COMMISSION ACTION

NCPC File Nos. MP03/6805

**THE YARDS AT THE SOUTHEAST FEDERAL CENTER
WATERFRONT PARK, PHASE II
M Street and New Jersey Avenue, SE
Washington, D.C.**

STAFF RECOMMENDATION

Above, elevations of the three retail buildings from the park. Below, elevations from Water Street, SE.

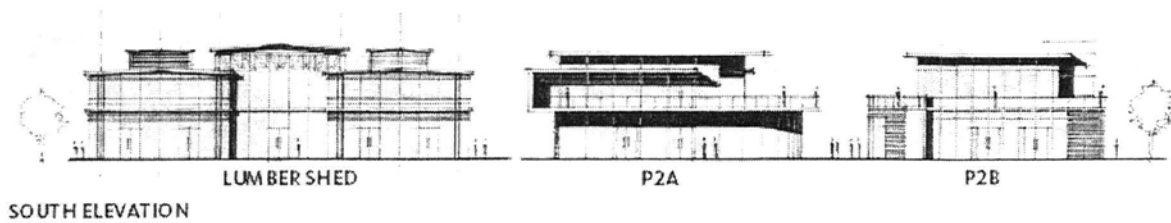
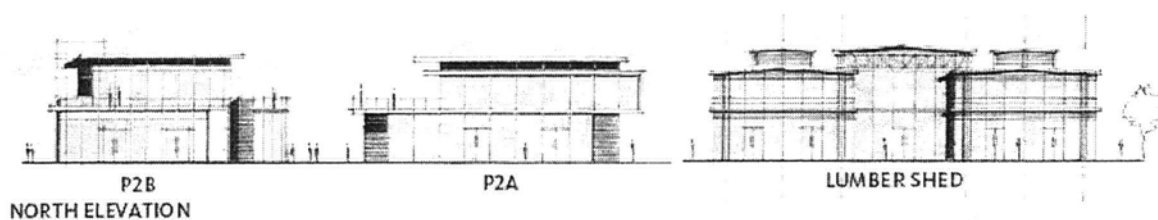
The proposed new retail buildings reflect both the materials and character of the Lumber Shed but also their own era of design, as required in the Master Plan and design guidelines for The Yards. Of industrial and marine materials, the new buildings are well-scaled for the park and relatively open and glassy, appropriately signaling their role as pavilions within the park. They will draw the public to the park and contribute to activities within the park. Under 40 feet in height, they will be distinct from the taller office and residential buildings to the north of Water Street, SE. They intentionally form an urban edge at the intersection of 4th and Water Streets but are more organically shaped on their other facades, as befit pavilions on a public plaza within a park. The dynamic forms will draw the public into the park from Water Street and open dramatically to fuller views of the plaza, the landscaped park elements, the visual marker, and the river.

COLLAGE IMAGES OF VISUAL MARKER ON BOARDWALK

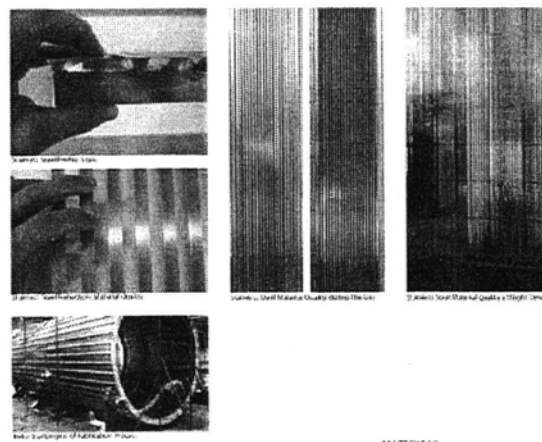
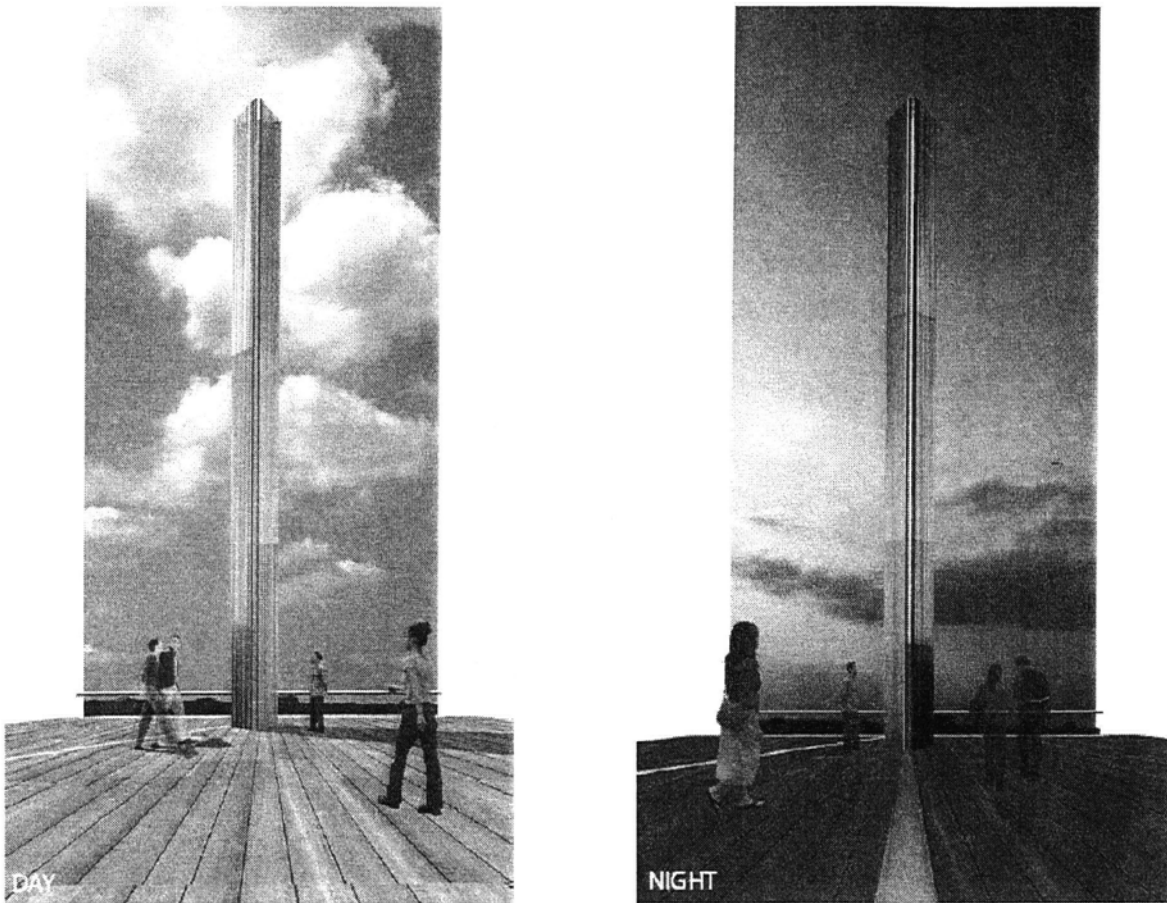
The proposed visual marker on the boardwalk will be visible from the edge of the park to the north as well as from the water and south bank of the Anacostia River. It is an elegant design that is austere in form, material, and construction, conveying the contemporary character of new construction at The Yards and also the industrial history of the site.

The staff supports the visual marker's design and the proposed height of 70 feet, acknowledging that the height exceeds that allowed for structures in the waterfront zone designation and will require approval by the Zoning Commission. The marker is an unoccupied tower and therefore complies with the Height of Buildings Act.
